**ATLANTIC COAST PIPELINE, LLC  
ATLANTIC COAST PIPELINE**

**DOMINION TRANSMISSION, INC.  
SUPPLY HEADER PROJECT**

**Revised Site Specific Geohazard Mitigation Design Drawings**

Date: 22 December, 2016  
To: Colin Olness, Dominion  
Copies to: Tony Rice, Geosyntec Seattle  
From: Logan Brant, Geosyntec Houston  
Subject: Revision C Updates to Site Specific Geohazard Mitigation Design Drawings  
MNF and GWNF Sites - Atlantic Coast Pipeline  
Geosyntec Project: TXG0007 / 013 / 1210

SECTION D - D' (STA 4432+00)

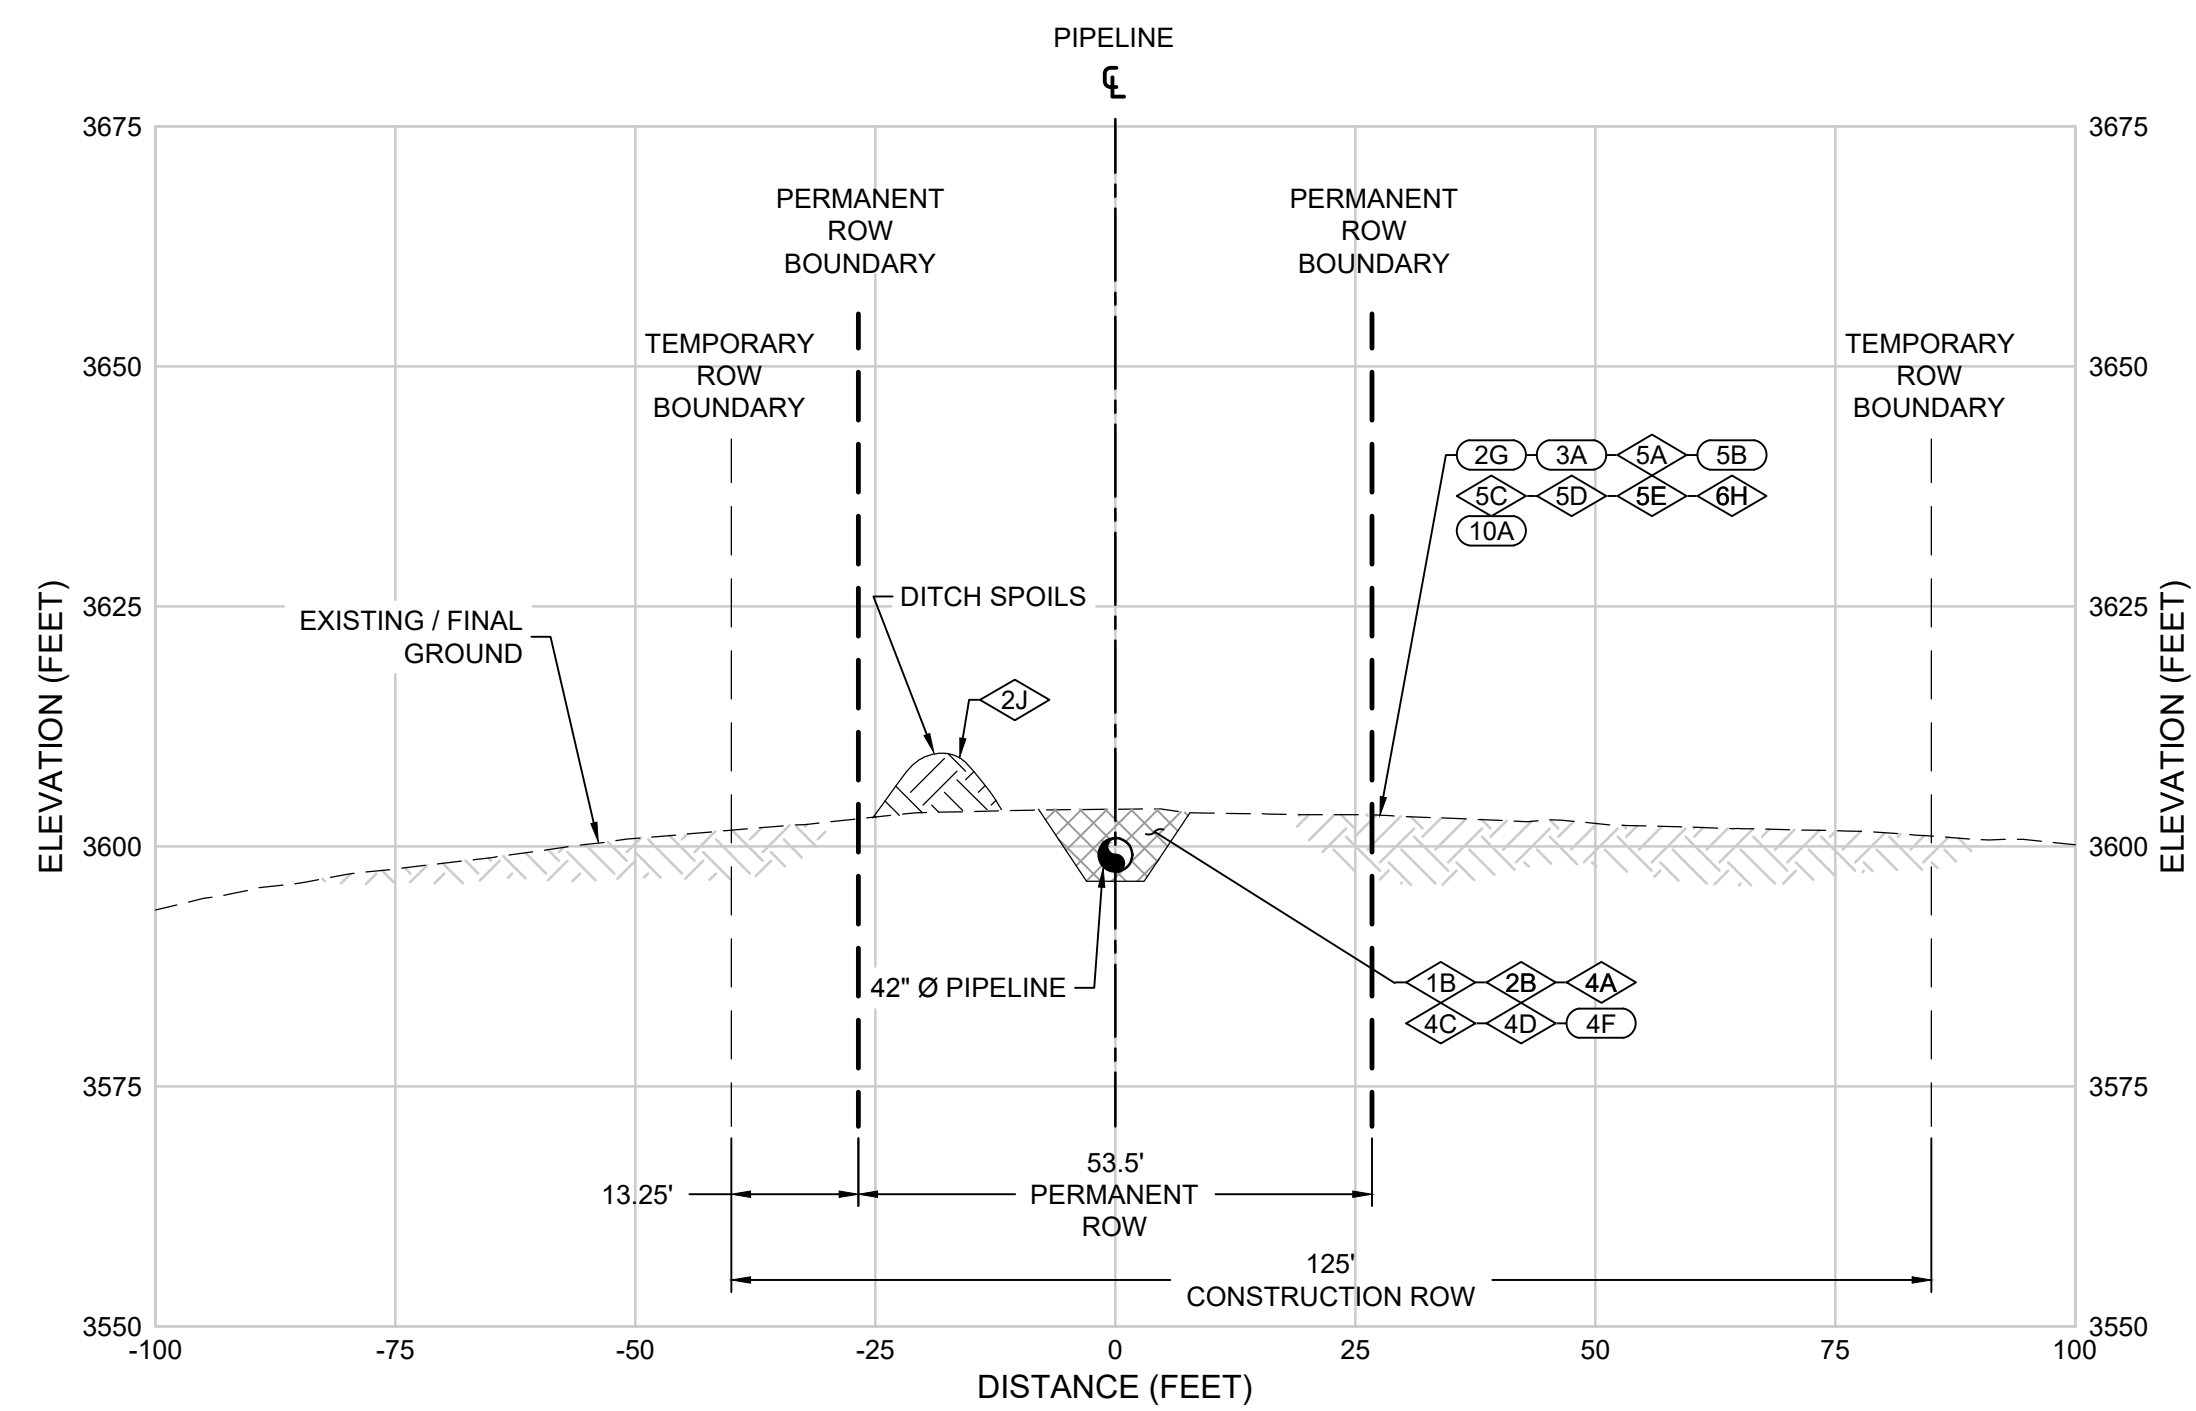
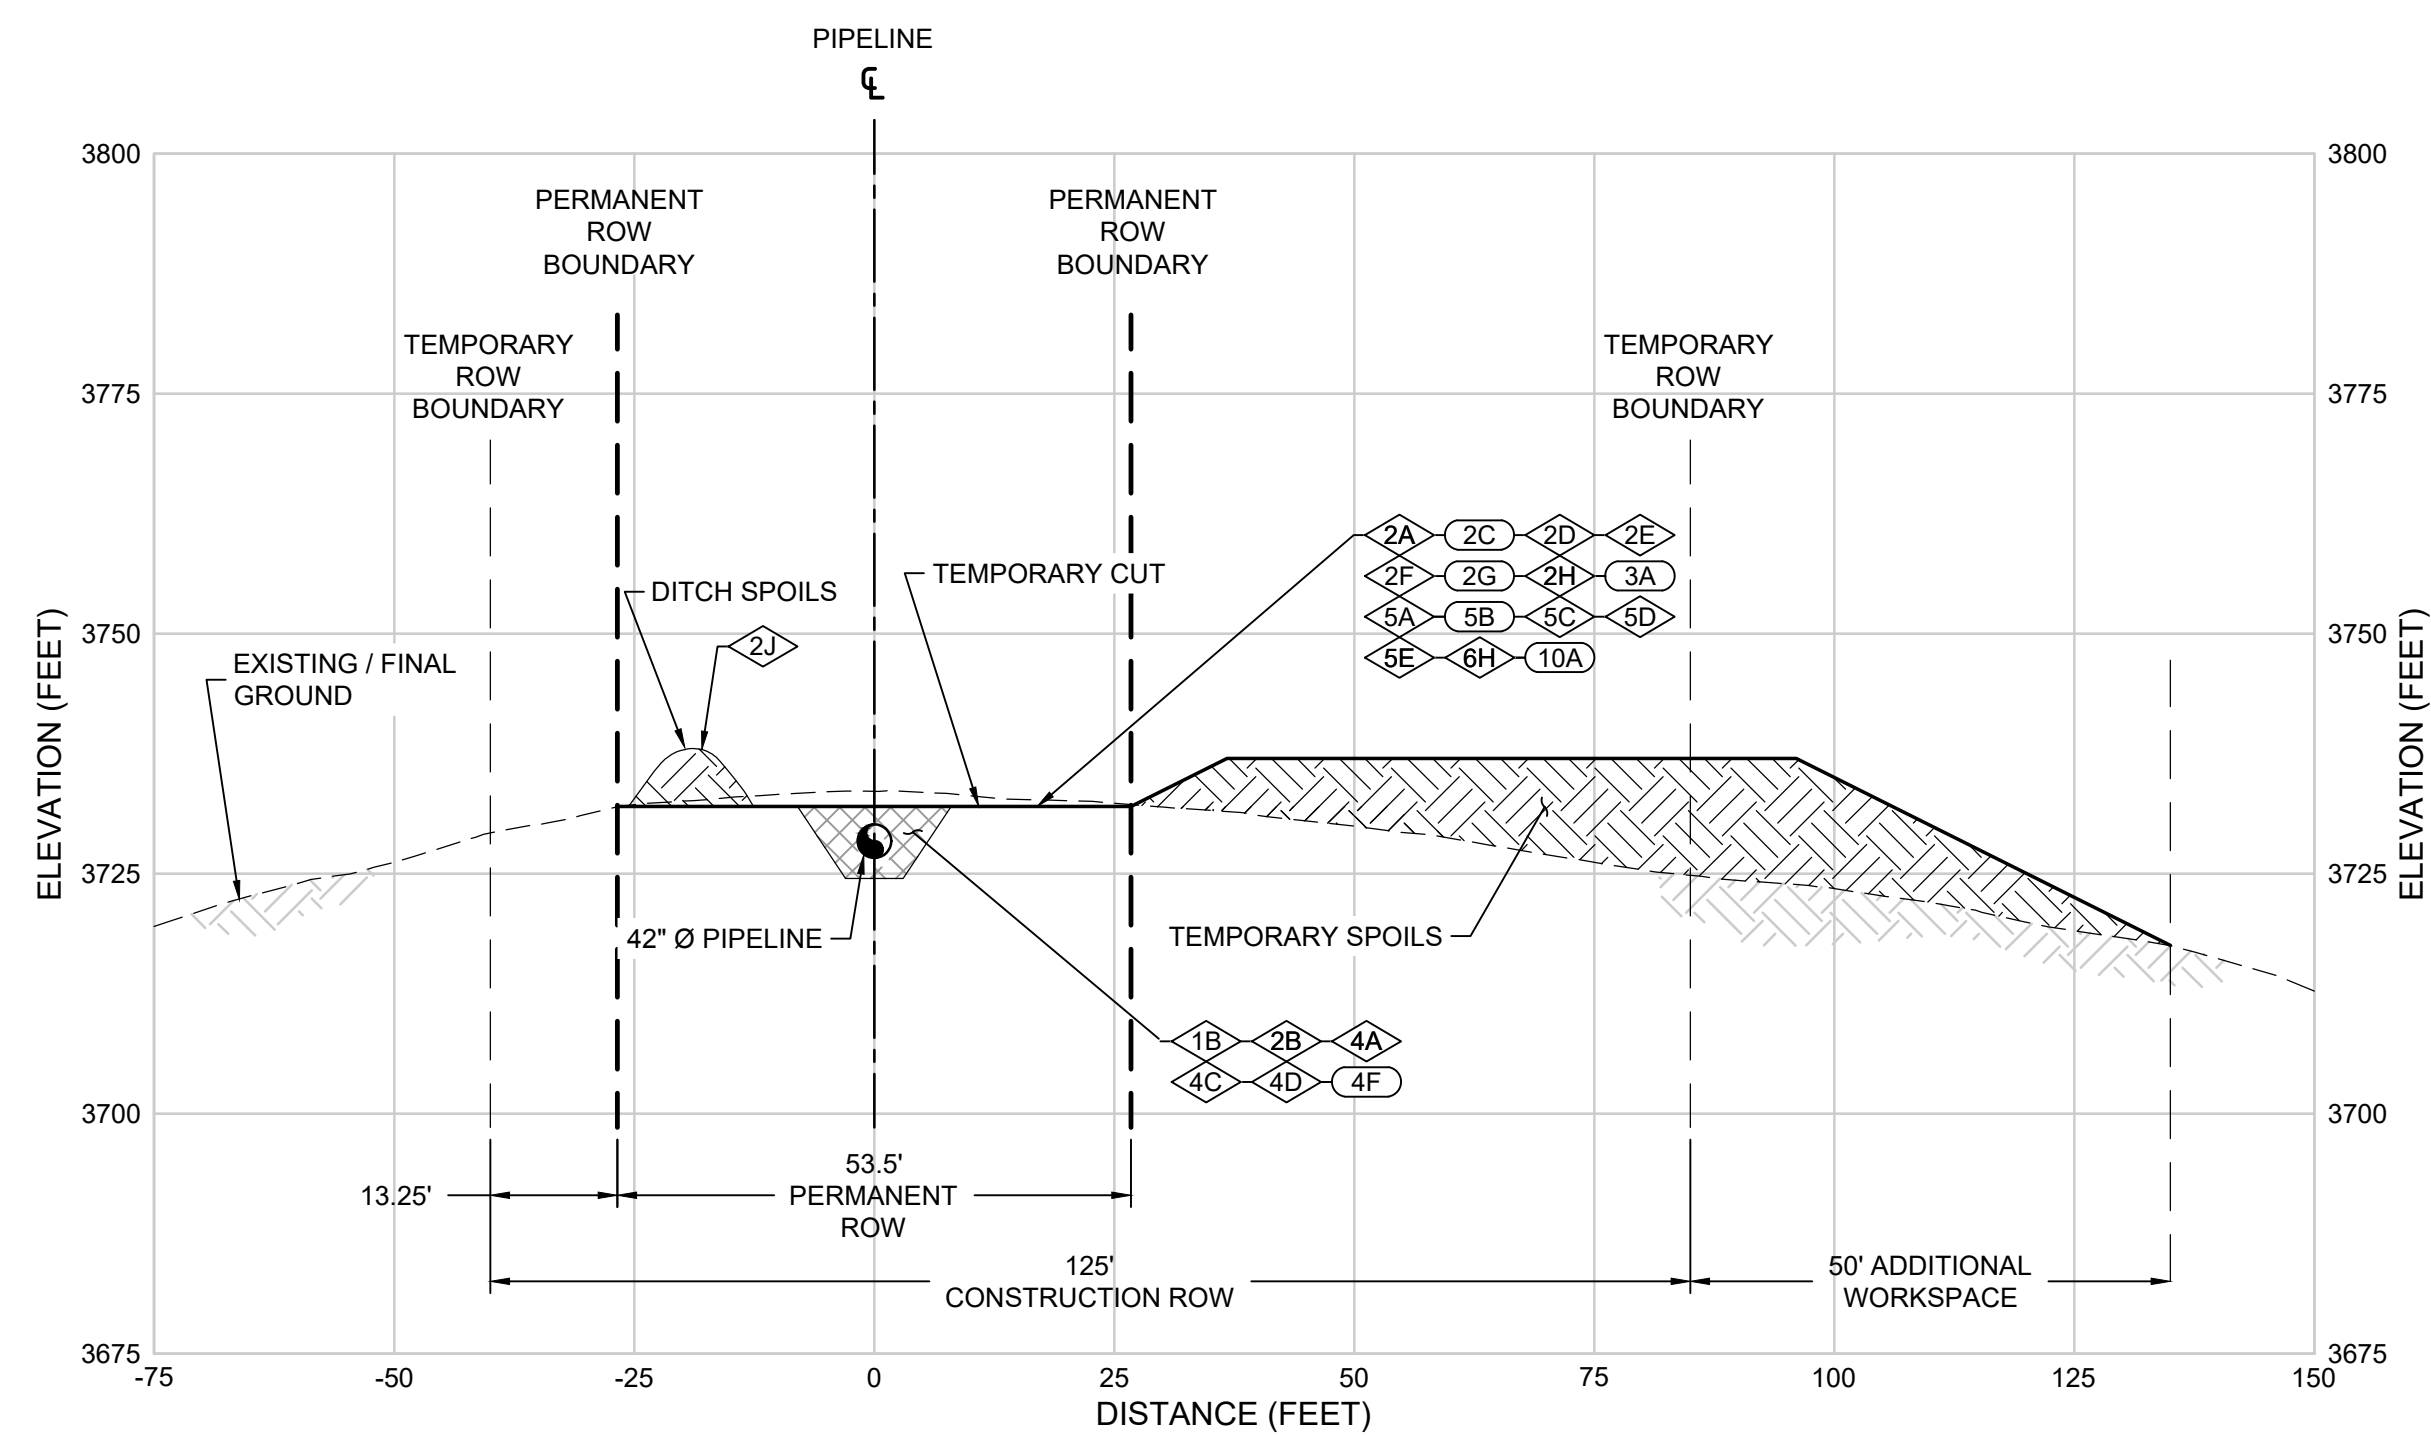
ACP AP-1 MP 73.20 to 73.50 – Sections:

- Four additional sections were added to the drawing set, including one cut through the additional temporary work space. Previous Section B-B' is now C-C' (4428+50) and previous Section C-C' is now F-F' (STA 4439+00). The new sections include Section B-B' (STA 4425+00), Section D-D' (STA 4432+00), Section E-E' (STA 4435+50) and Section G-G' (STA 4442+50). The six sections are spaced at approximately 350 ft intervals along the alignment. This change required presenting the sections on three drawings instead of just one.
- Cutting and filling for ROW grading at individual sections has been revised to better approximate the balanced temporary grading planned for this area of the project.
- Note 3 revised to include sentence indicating that “Temporary cut / fill is for illustrative purposes.”
- Revision C line added to the revision block.

Tom Collins indicated that the nature of the surface and the amount of materials to be placed need to be better shown in cross section. We have incorporated a cross section through the extra temporary workspace to illustrate the temporary placement of fill at the MNF site.

TITLE: **GEOHAZARD MITIGATION SITE SPECIFIC DESIGN  
PLAN AND PROFILE A-A'**

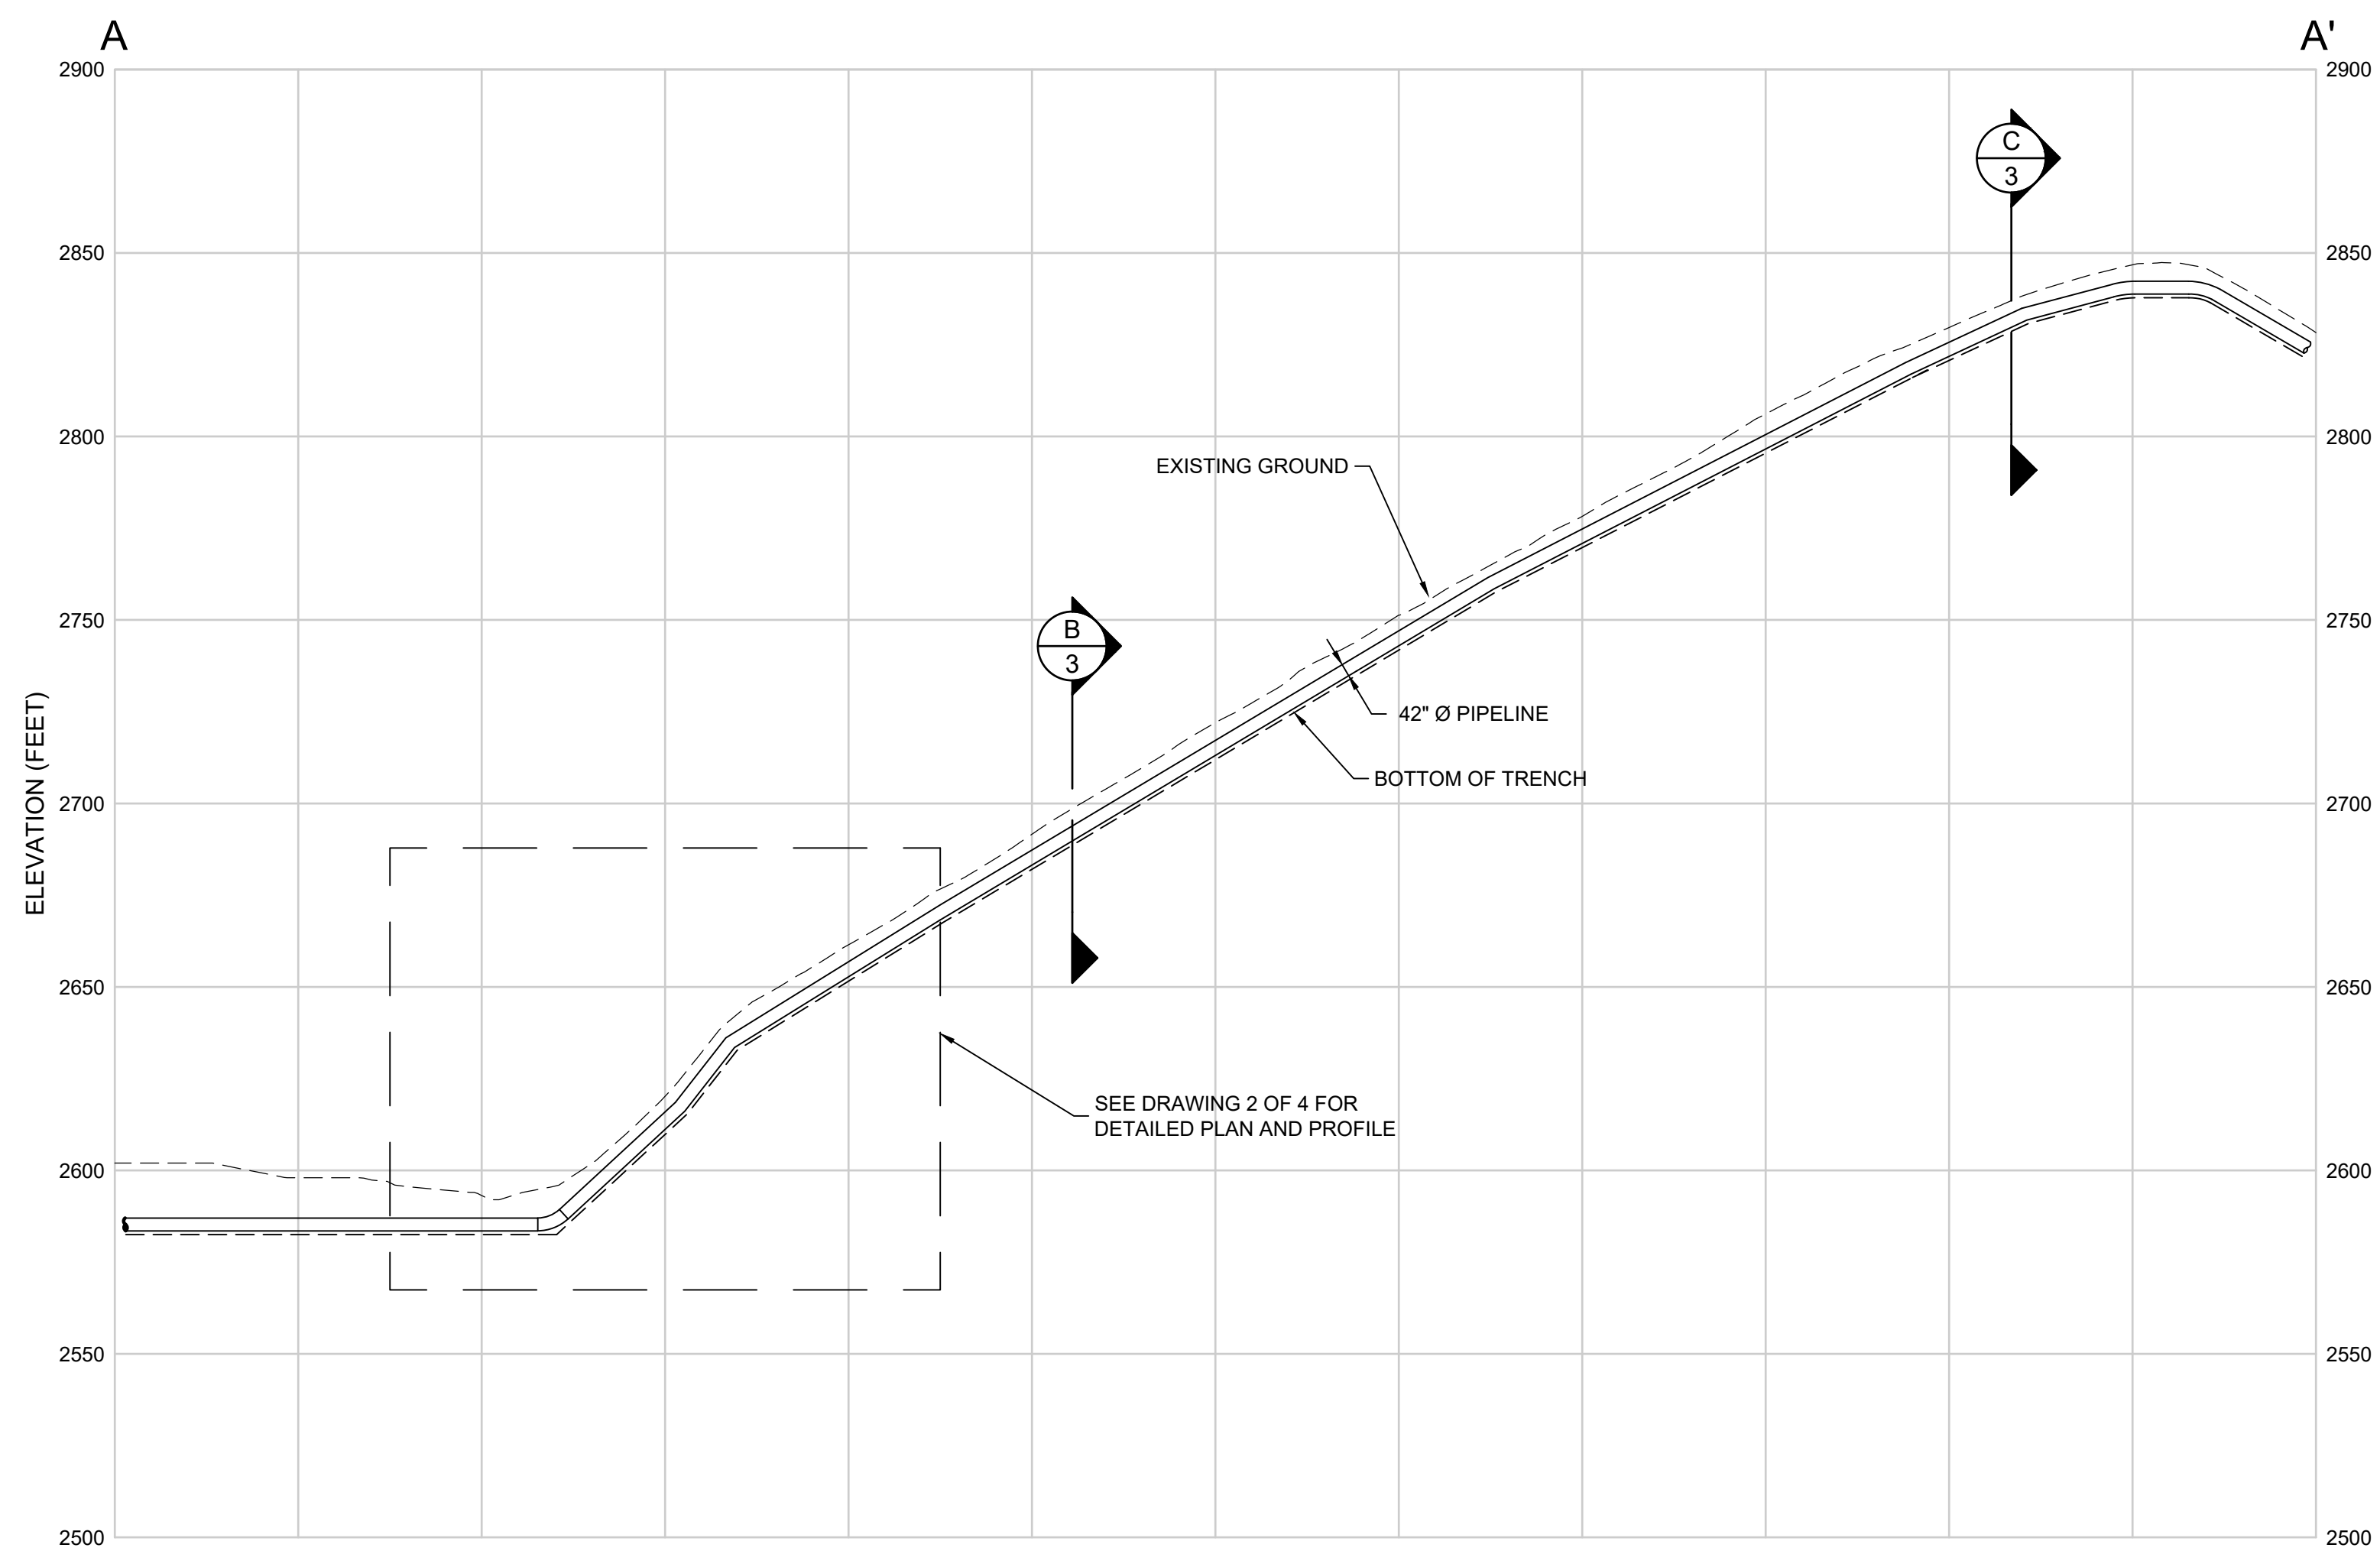
ACP AP-1 MP 84.95 to 85.05 – Plan and Profile A-A':

- Marker for Section C-C' on Plan and Profile moved to STA 5351+00, in order to include additional temporary work spaces, located near the top of the slope.
- Revision C line added to the revision block.
- Drawing set expanded from 4 to 5 drawings, so drawing numbering now shows “of 5”.
